HITACHI SEMICONDUCTOR TECHNICAL UPDATE

Classification of Production	MPU			No	TN-SH7-341B/E	Rev	2 nd	
THEME	Usage notice in power supply of SH7751 and SH7751R Classification of Information		 Spec change Supplement of Documents Limitation of Use Change of Mask Change of Production Line 					
PRODUCT NAME	SH7751, SH7751R	Lot No.		SH7751 series Hardware manual			Effective Date	
		ALL	Reference Documents			Eternit	у

Figure 1. How to once set clock operation mode as mode 6.

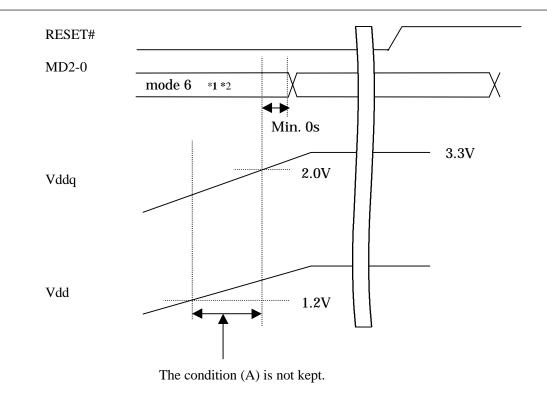
If the following condition (A) is not kept in supplying power, the clock may not be output correctly from the CKIO pin because PLL2 may oscillate abnormally.

When VDDs (VDD, VDD-PLL1/2) are higher than 1.2V, VDDQs (VDDQ, VDD-CPG, VDD-RTC) must be higher than 2.0V.

- (1) Set the clock operation mode 6^{*1} in supplying power, and secure the condition (A), then set desired clock operation mode (shown in Figure 1).
- (2) Once start in the clock operation mode 6*1, then set desired frequencies by changing FRQCR (The clock divider 1 can't be used in this clock operation mode).
- (3) Once stop PLL2 (to write 0 to FRQCR.PLL2EN), and keep the FRQCR.PLL2EN as 0 for more than 1us, then restart PLL2 (to write 1 to FRQCR.PLL2EN). (It is not guaranteed that the CKIO output is stable until this operation is finished. If you use this workaround, please check the noise or the clock network on the real board.)
